**Comments on the Final Environmental Impact Statement  
for the  
Northern Integrated Supply Project**

**Dated: October 4, 2018**

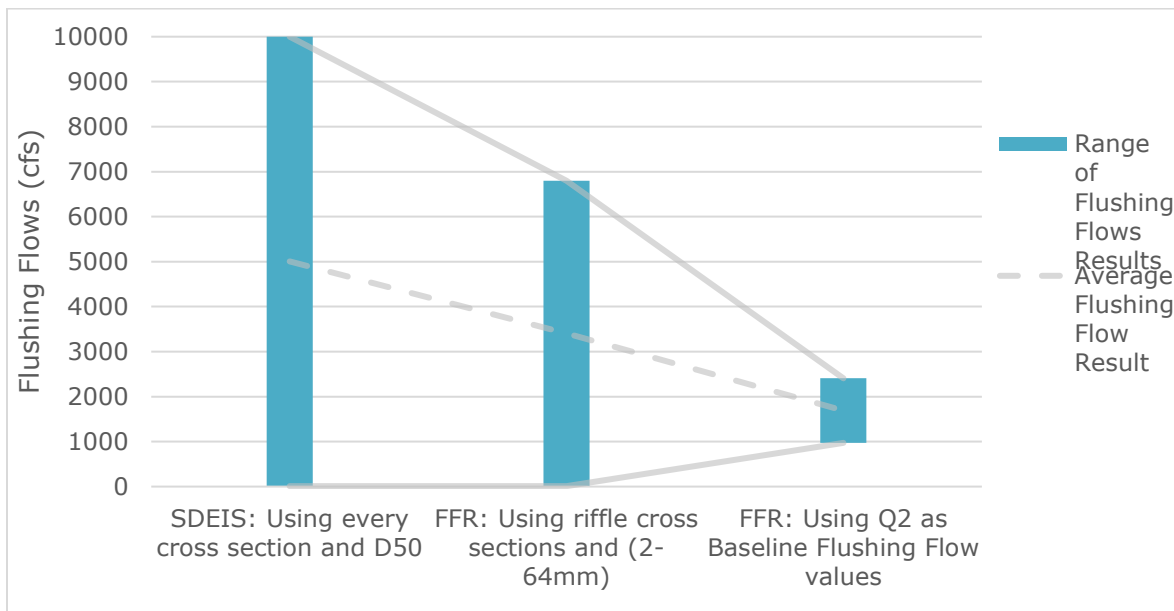
Fort Collins has reviewed the FEIS and related reports to understand the assumptions, methods, analyses, and conclusions reached regarding the current conditions of the Poudre River and the potential impacts of NISP operations. The Stream Morphology and Sediment Transport Technical Report presented conclusions on impacts to the Poudre River from NISP flow operations, including conclusions pertaining to potential impacts to various environmental flows, sediment transport, vegetation encroachment, and channel narrowing.

In response to deficiencies in those reports and conclusions, additional analyses were performed to garner a better understanding of how NISP might impact resiliency and flood risk in Fort Collins, as it pertains both to the Poudre River and the people affected by its flood storage benefits, recreational values, and ecological functions. These additional analyses included hydraulic modeling of a wide range of flow conditions in the river, calculations of bed mobility and sediment transport capacity, historic data review, and field observations and measurements. The results of these analyses are presented and interpreted in Appendix B (referred to herein as the "Fort Collins Geomorphology Report"). From these analyses, three general comments have been identified and are discussed below.

a conceptual image of future flows with NISP compared to today's flows

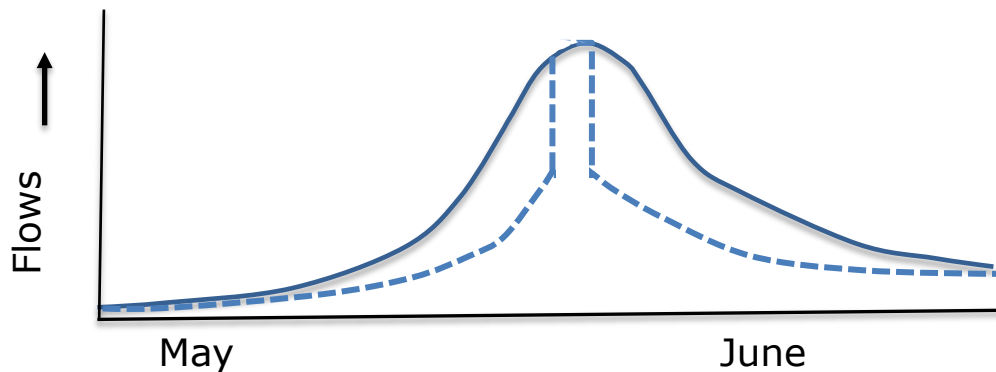
significant. However, impacts to the Poudre River from such a modified descending limb are not analyzed in the FEIS.

The conceptual image below is Fort Collins' current understanding of how NISP's peak flow operations Program may affect current flows. The impacts to the descending limb will shorten duration of peak flows causing impacts to geomorphology, riparian and wetland habitat, including rapid declines in river flow, which could (1) preclude successful establishment of cottonwood seedling, (2) cause stranding of fish and affect critical life cycle behaviors such as spawning and migration patterns of the small native fish, and (3) reduce sediment transport and increase aggradation through Fort Collins, resulting in increased flood risk. Last, if flows at the tail end of the descending limb are reduced, there will be a greater impact on total boatable days. The lack of analysis of a descending limb precludes a meaningful and adequate understanding of the Project impacts and the sufficiency of mitigation, and fails to comply with CWA regulations requiring adequate analysis of the "nature and degree of effect that the proposed discharge will have individually and cumulatively on water, current patterns, circulation including downstream flows, and normal water fluctuation." 40 C.F.R. 230.11(b); *see also Utahns for Better Transp.*, 305 F.3d at 1162 ("The purpose of NEPA is to require agencies to consider environmentally significant aspects of a proposed action, and, in so doing, let the public know that the agency's decisionmaking process includes environmental concerns.").

Northern should be required to provide, at minimum, a complete three-day peak flow in all years. If the Peak Flow Operations Program remains in effect, Fort Collins requests clarification on the implementation and effects of the program, including how stream flows are required to be forecasted and how the averages are to be calculated. Northern should also be required to annually publish notice of how the Peak Flow Operations Program was implemented. Northern should also be required to perform additional mitigation to compensate for the apparent lack of analysis of the impacts caused by increased diversions following the peak flow bypass period (under a complete three-day peak flow or something less under the Peak Flow Operations Program).
